Project	<b>IEEE 802.16 Broadband Wireless Access Working Group</b> < <a href="http://ieee802.org/16">http://ieee802.org/16</a> >	
Title	<b>Letter Ballot 13 Comment Addendum</b>	
Date Submitted	<b>2003-10-30</b>	
Source(s)	Robert Nelson MacPhy Technologies 1104 Pittsburgh Landing Richardson, TX 75080	Voice: 972-239-9224 Fax: 972-671-1455 bob_nelson@ieee.org
Re:	Letter Ballot 13 on document <i>IEEE P802.16-REVd/D1-2003</i>	
Abstract	Additional letter ballot comments too large or detailed for inclusion under Commentary	
Purpose	Contains text and editing instructions referenced by author's Commentary comment submission	
Notice	This document has been prepared to assist IEEE 802.16. It is offered as a basis for discussion and is not binding on the contributing individual(s) or organization(s). The material in this document is subject to change in form and content after further study. The contributor(s) reserve(s) the right to add, amend or withdraw material contained herein.

# Letter Ballot #13

## Comments Addendum

### CORRECTIONS FOR FULL STC AND TDMA SUPPORT

Figure 187—Fundamental burst **set** framing elements

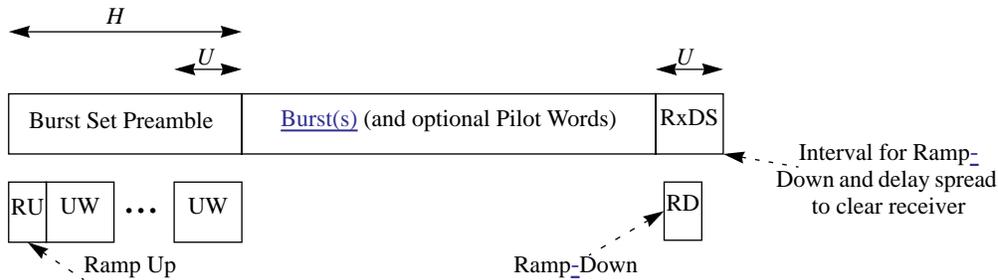
8.3.1.4.1 Fundamental burst **set** framing elements

As Figure 187 illustrates, a burst **set** consists of three fundamental framing elements: a **B**urst **set** **P**reamble that includes ramp-up; a **P**ayload **one or more bursts**; and a Receiver Delay Spread Clearing **Interval** (RxDS) interval that includes ramp-down.

Figure 188—Burst **Set** Preamble composition

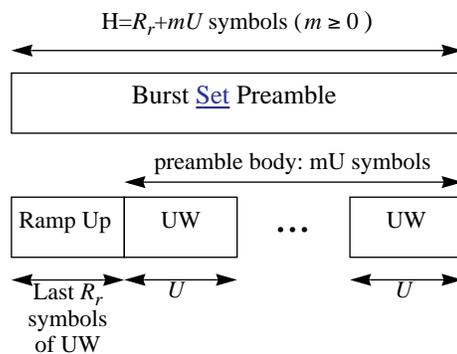
A burst **set** preamble shall consist of a ramp-up region followed by a preamble body. Burst profile ([on uplink](#)) or [extended IE \(on downlink\)](#) parameters shall specify  $R_r$ , the length of the ramp-up region in symbols, and  $m$ , the number of Unique Words composing the preamble body. The ~~burst-profile~~ [preamble specification](#) shall also **specify include**  $U$ , the number of symbols in a Unique Word.

A burst **set** preamble shall be constructed from the last  $R_r$  symbols of a Unique Word (see Table 165) followed by an integer multiple of Unique Words, each Unique Word being  $U$  symbols in length. Figure 188 illustrates this requirement.

Figure 190—Example of FDD frame format

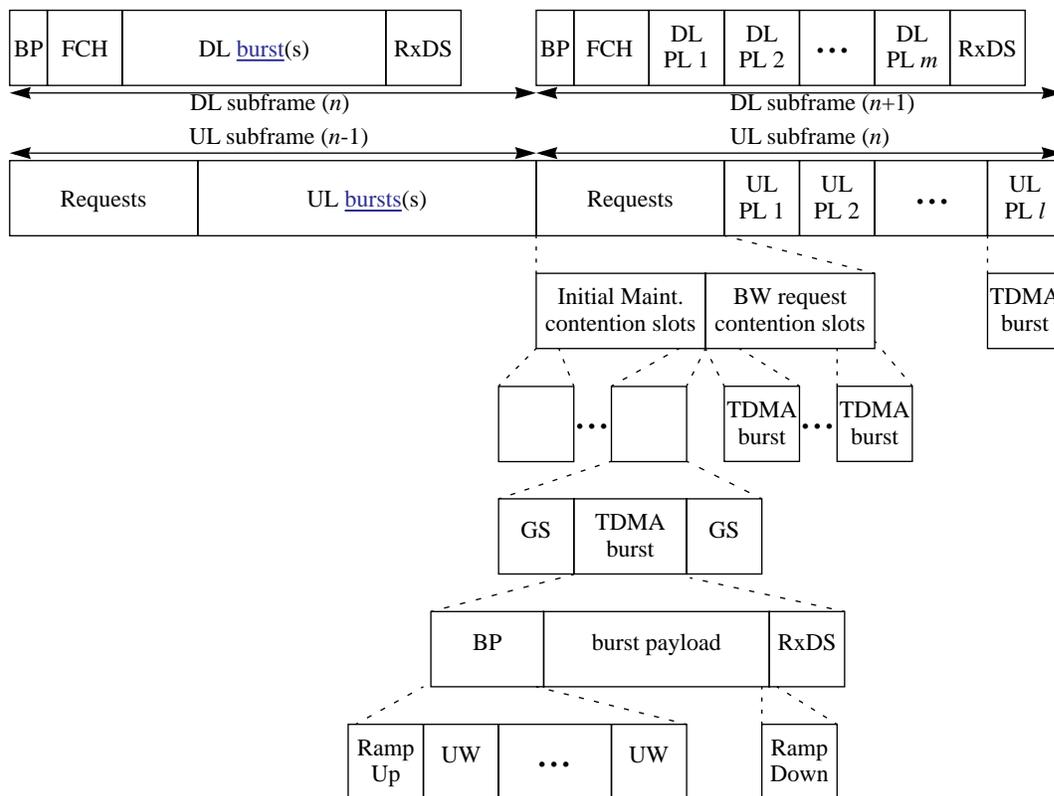
An example FDD system with TDM downlink is illustrated in Figure 190. As Figure 190 illustrates, downlink and uplink subframes shall coincide in length, and shall repeat at regular (MAC defined) constant intervals.

A downlink burst frame shall not exceed the length of a downlink subframe, but it need not fill the entire downlink subframe. Also, although not illustrated in Figure 190, the capability to support several downlink burst sets within a downlink subframe is mandatory.

The first burst set in each downlink subframe shall commence with a burst set preamble (BP), and shall be directly followed by a Frame Control Header (FCH), a ~~broadcast~~ payload that may contain DCD, UCD and MAPs. Only the first burst set in a downlink subframe shall contain the FCH.

As Figure 190 illustrates, uplink burst **sets** are TDMA, and shall be constructed from a burst **set** preamble (BP), including ramp<sub>up</sub>; a burst **payload**; and an RxDS, including ramp<sub>down</sub>. SSTGs separate the burst **set** transmissions

Figure 191—Example of TDD frame format

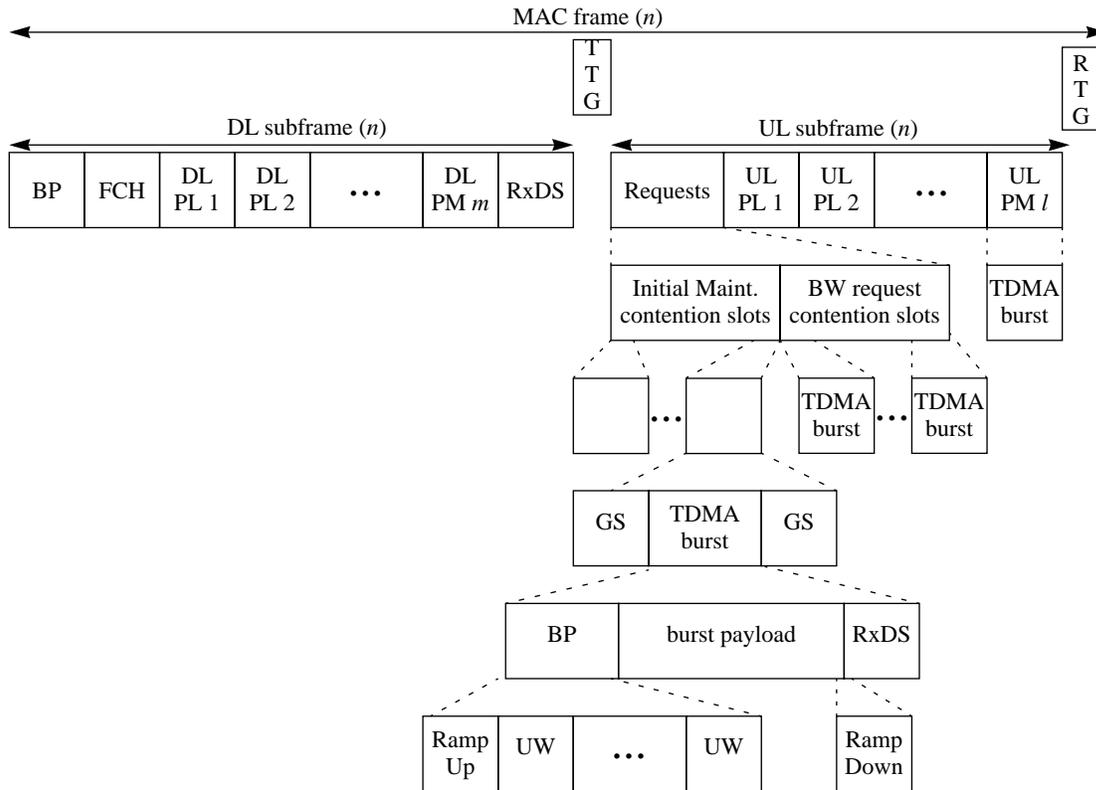
Figure 191 illustrates TDD operation with a single burst [set](#) on the TDM downlink. In TDD, the downlink and uplink alternate, ~~between~~ occupying a shared frame, with the downlink subframe preceding the uplink subframe. The size of [the](#) shared frame shall be constant; however, the downlink and uplink subframe sizes within the shared frame shall vary according to allocations directed by the FCH. Although Figure 191 illustrates a single TDM burst [set](#) per downlink subframe, the capability to accommodate several TDM burst [sets](#) is mandatory, with the first burst [set](#) in the downlink duplex subframe containing the FCH.

**Figure 195—STC ~~frame~~ burst set preamble**

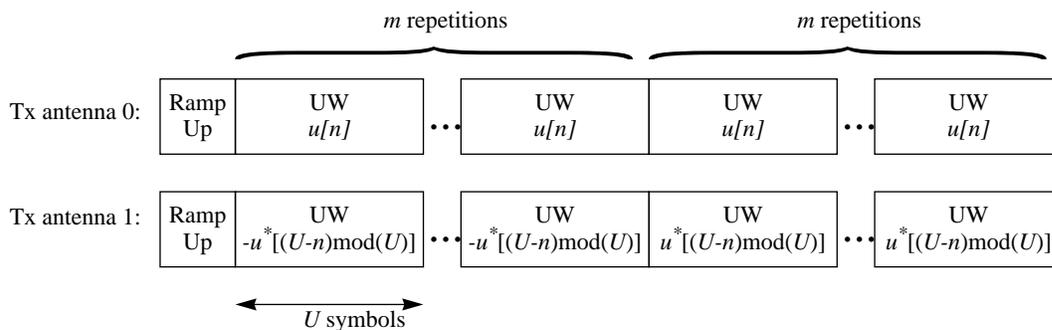
Figure 195 illustrates that the burst ~~frame~~ set preamble shall be used for burst sets utilizing STC transmit diversity encoding. The number of UW Unique Word blocks composing a STC burst set preamble is a ~~burst profile~~ parameter of the Burst Set Delimiter Extended IE (for downlink) or burst profile (for uplink), ~~through reuse of the general burst profile encoding for the number of UWs in a preamble~~. However, since two channels shall be estimated, the total number of UWs used to construct an STC burst set preamble shall be twice the ~~number~~ parameter value specified ~~in the burst profile encoding~~.
